## City Council Staff Report

SUBJECT: APPROVE THE PURCHASE OF TWO COOLING TOWERS FROM ALLISON MECHANICAL, INC.

BID NO. 14-07  
BID COST PROPOSAL PRICING FOR  
FURNISHING TWO (2) NEW BAC (OR EQUAL) COOLING TOWERS

**Model:** VT0-075- COOLING TOWER

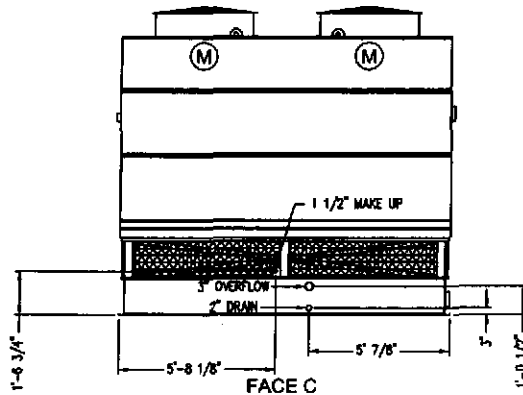
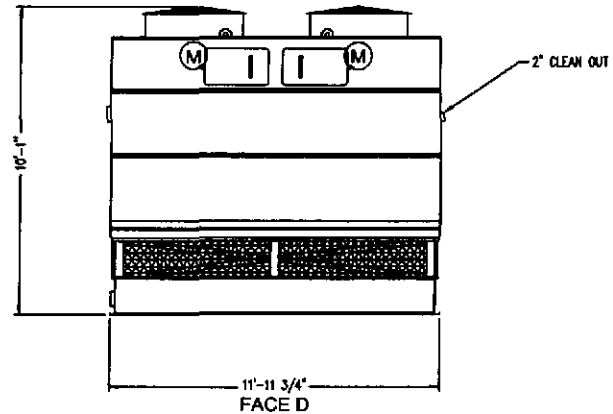
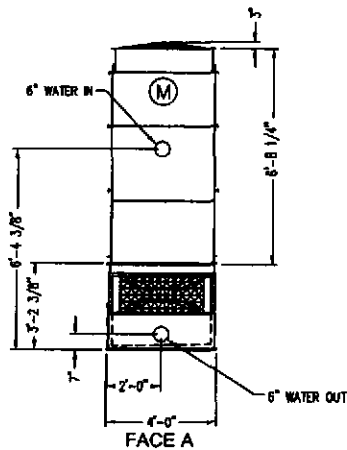
- 1) Furnish BAC Model PT2-0412A-1G1/S in lieu of specified Model PT2-D412A-161.
- 2) Furnish BAC Model VT0-075-K in lieu of specified Model VNT-90D.
- 3) Model VT0-075-K shall be forced in lieu of induced draft.

- Specifications call for Model VNT-90D, which is an obsolete model # that is no longer available.
- The recommended replacement unit is the VT0-75-K (proposed here).
- See attached dimensional drawing for details. Listed below are some (but not all) of the differences:
  - Weight: VNT-90D was 2,470 lbs; VT0-75-K is 2,590 lbs
  - Height: VNT-90D was 8'; VT0-75-k is 9'
  - HP: VNT-90D was 15 hp; VT0-75-k is 10 hp
  - Connection locations may vary.

**PT2 Single Cell Unit Print  
Direct Drive**

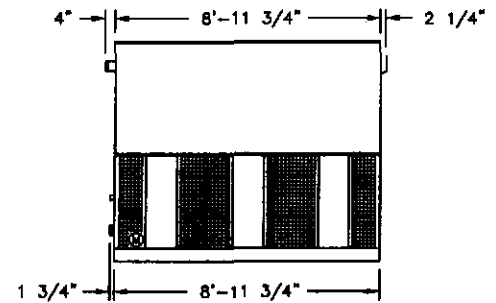
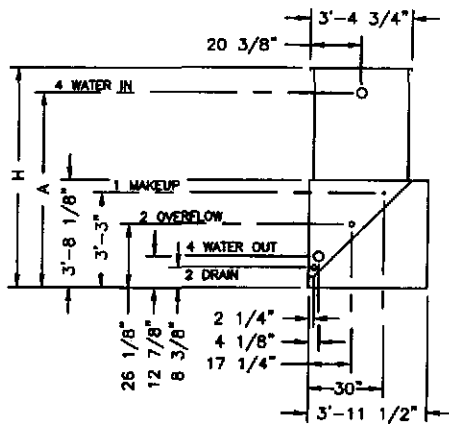
- Specifications call for Model PT2-D412A-161; Proposed unit is Model PT2-0412A-1G1
